8.6.11 Ford Ord Rec Users (FORU)

March 24, 2017

Re: Draft Environmental Impact Report/Environmental Impact Statement
Monterey Peninsula Water Supply Project

Figure 1.1 Declining Demand over 20 years on the Monterey Peninsula

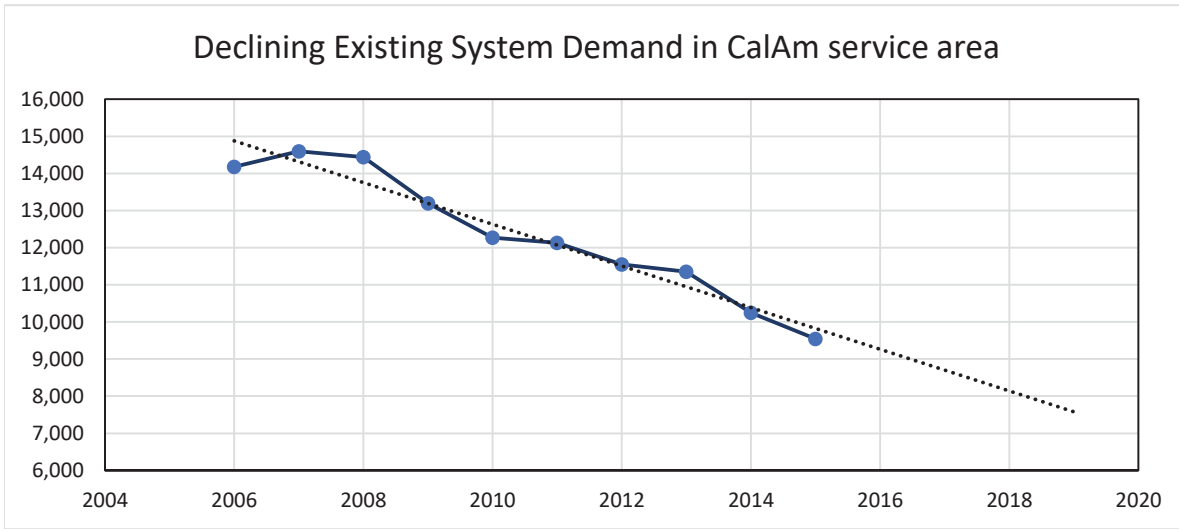
1. **The Assessment of Water Demand is greatly exaggerated, resulting in greater water for new development.**
 - a. **The estimate of existing system demand ignores mandatory and voluntary conservation programs.**

The analysis of existing system demand inappropriately ignores the history of water conservation measures that have limited the possibility of increases in total system demand in the service area to 2010 levels. The failure to consider the enduring reductions in water use resulting from these conservation measures means that the estimated service demand is too high. This in turn means that should the people of Monterey continue to conserve as they have and the conservation measures installed continue to reduce demand, the project will result in substantially more water being available to induce new development.

The analysis of water demand in the DEIR/EIS assumes, unrealistically, that the interannual variation in water supply is due solely to random variation across years and not due to any systematic trend in water use. However, Monterey Peninsula has been subject to a series of mandatory and voluntary measures to improve water efficiency (e.g., see label measures listed in Figure 1.1.) Because many of these measures are permanent (e.g., installation of new fixtures and tighter standards for new development), these gains in water efficiency cannot be expected to reverse due to the normal variation in peak demand or the return of wetter water years. Thus, it is unrealistic to anticipate such high demand from existing users who have moved sharply to conserve water. These measures are not going to be reversed, as the hardware is already installed, and new construction and renovations would be subject to tighter standards than prevailed twenty or even seven years ago. As noted the peak demand is to be determined based on the prior ten years, but that record shows the last ten years continue a trend of greater efficiency and reduced demand that has continued across many business cycles over the last 20 years (see Figure 1 for the
